Service Letter: 457

Title: Lycoming Electronic Ignition System Placard

Models: 8GCBC (S/N's 611-2021, 614-2021, 615-2021, 616-2021, 617-2021, 618-2021)

**Figure 2: 11-1264 Placard Placement**

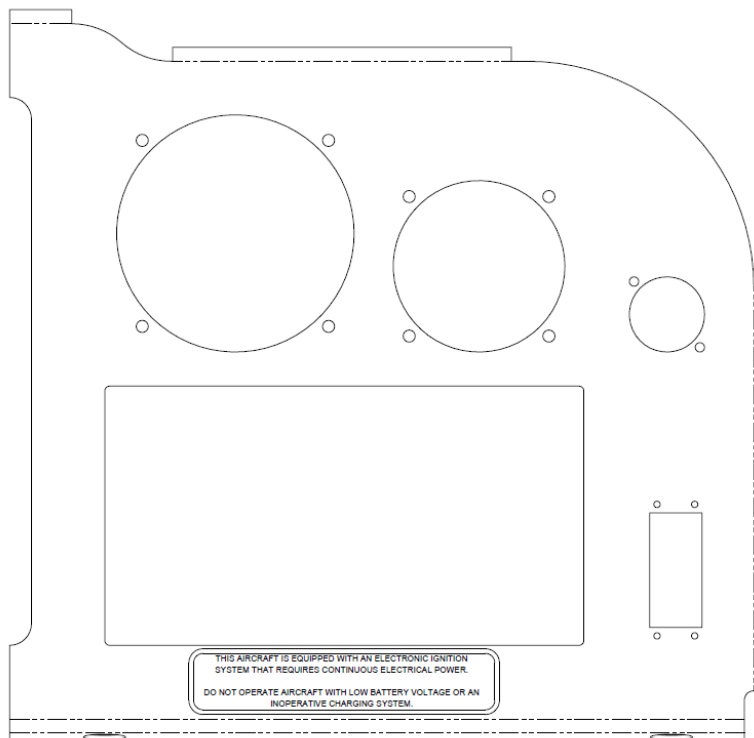
2. If the placard is missing, apply placard to instrument panel. Clean instrument panel prior to application. Placard is to be centered below the radio stack. Placement can be seen in Figure 2.
